ADDENDUM No. 1

RFP No. 22-23

Justice Center HVAC Condenser Replacement

RCS075C_Drawing for ACCU-1

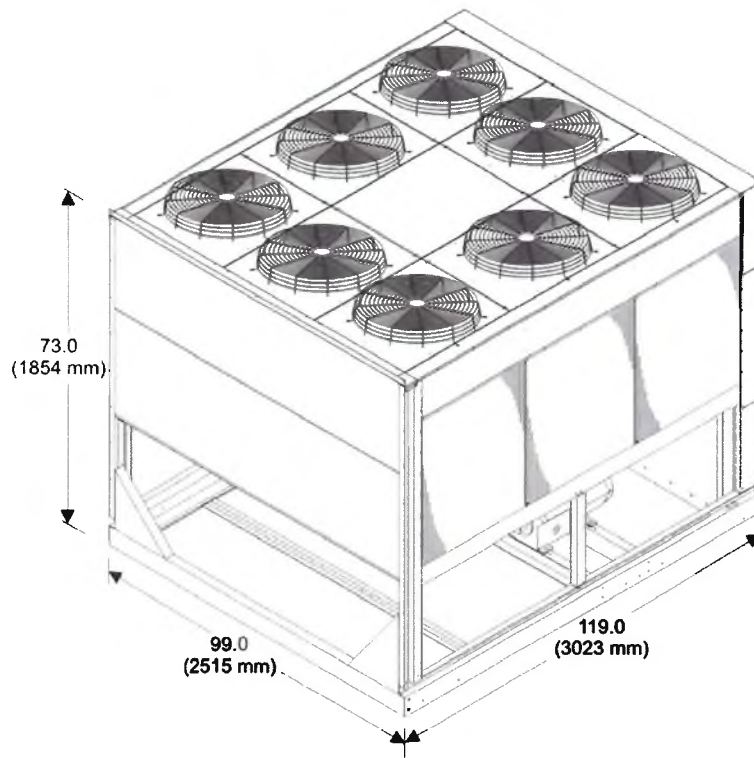
Question 2: Please provide any submittals/shop drawings of the pre-purchased condenser unit showing weight of unit, piping diagrams, and wiring diagrams?

Answer 2: See attached Technical data sheets and the quote from Thermalnetics for the ACCU.
